**Final
Environmental Impact Statement**

**REMEDIAL ACTIONS AT THE FORMER
UNION CARBIDE CORPORATION
URANIUM MILL SITES
RIFLE, GARFIELD COUNTY,
COLORADO**

MARCH 1990

Final Environmental Impact Statement
Remedial Actions at the
Former Union Carbide Corporation Uranium Mill Sites
Rifle, Garfield County, Colorado

FIGURE 4.12
OFF-PILE CONTAMINATION, OLD RIFLE SITE

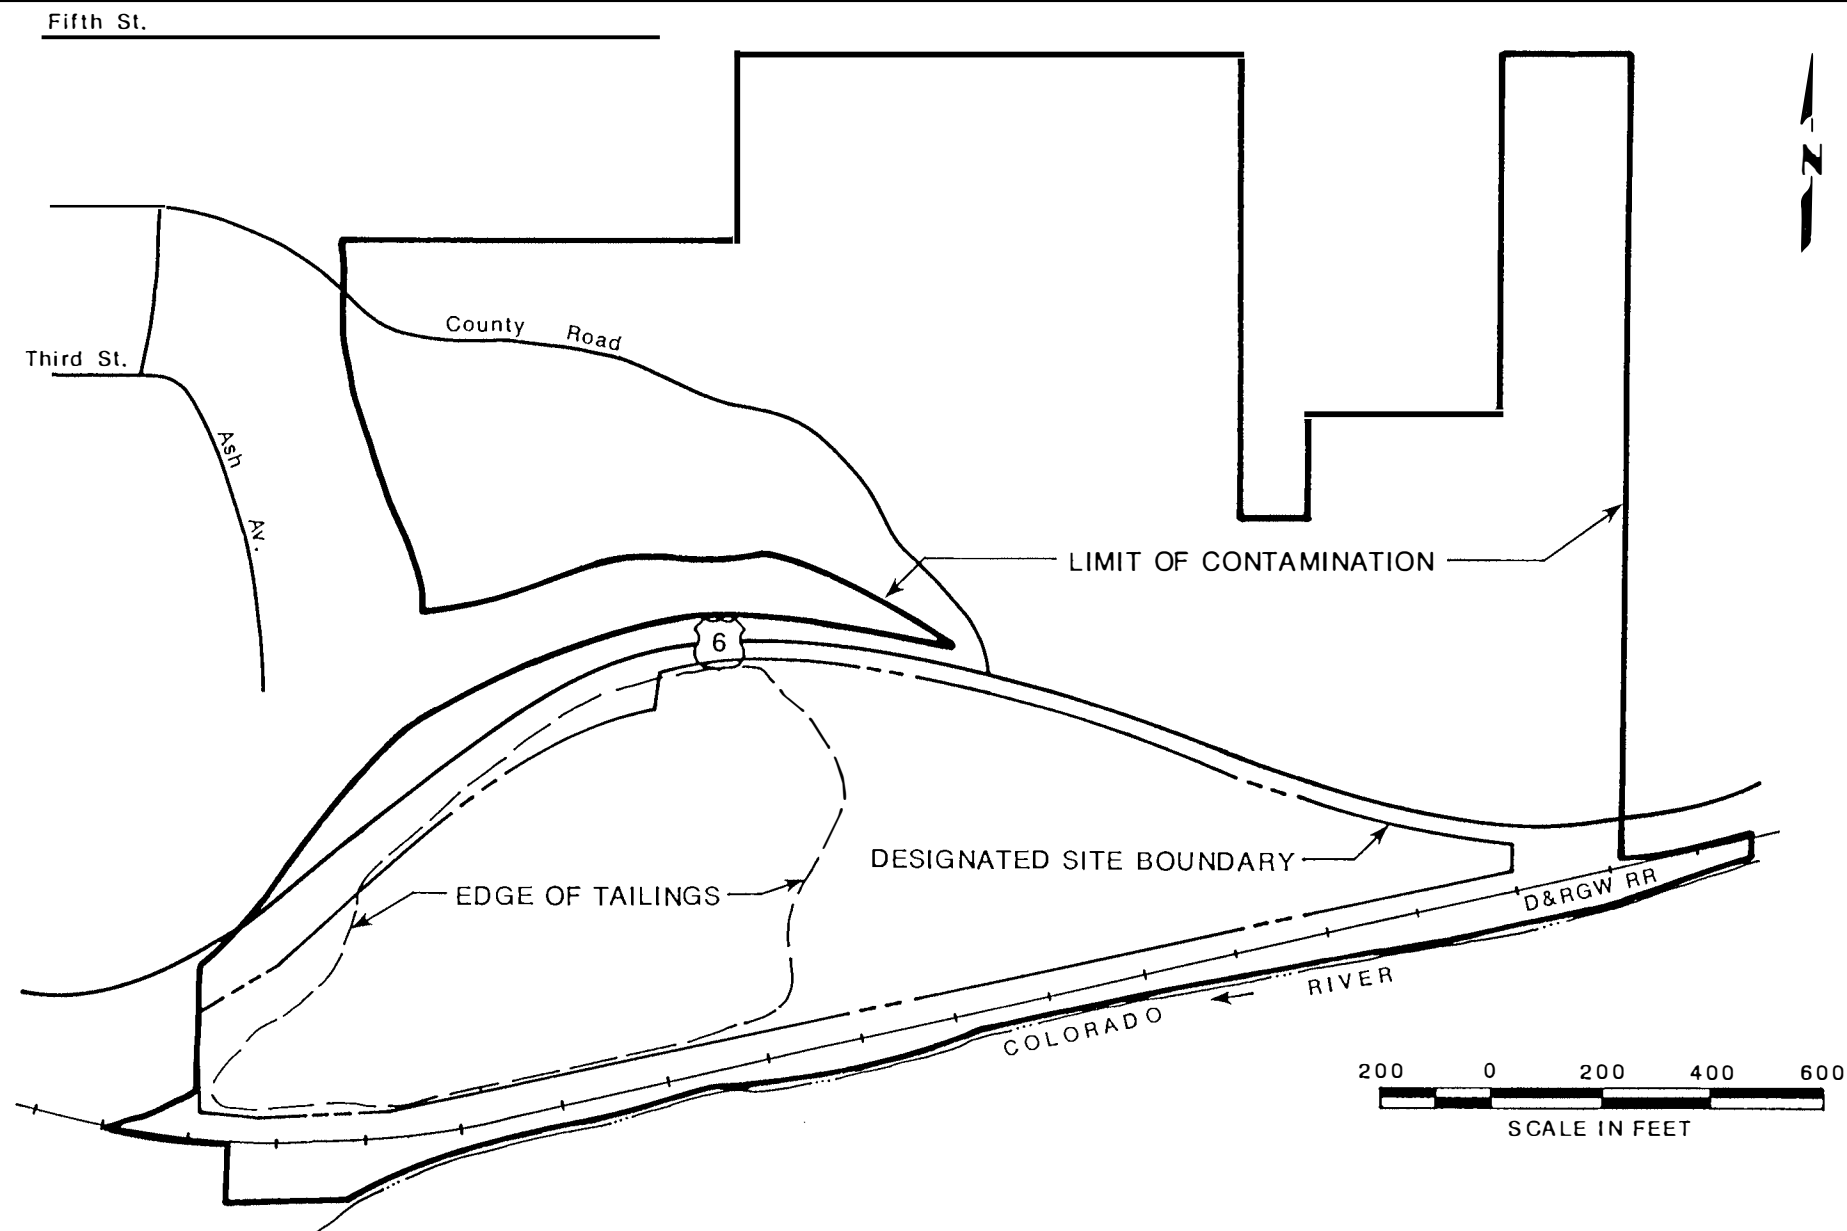
Section 4.2.1, Old Rifle site (page 67), indicates that the tailings have been dispersed by wind into the area of the State Nursing Home. The area is shown on Figure 4.9, Off-pile contamination, Old Rifle site (page 111). We believe that the State Nursing Home property is partially within the contaminated area, although the lack of landmarks on Figure 4.9 makes it difficult to assure an accurate location. Additionally, the scale on Figure 4.9 is incorrect.

The scale on Figure 4.9 has been corrected, and additional landmarks north of the Old Rifle tailings site have been added to the figure. In addition, the RAP and final engineering design contain more detailed maps and drawings of the areas to be decontaminated during the remedial actions. Please see the response to 6.4.1 above, regarding the removal of off-pile contamination during the remedial actions.
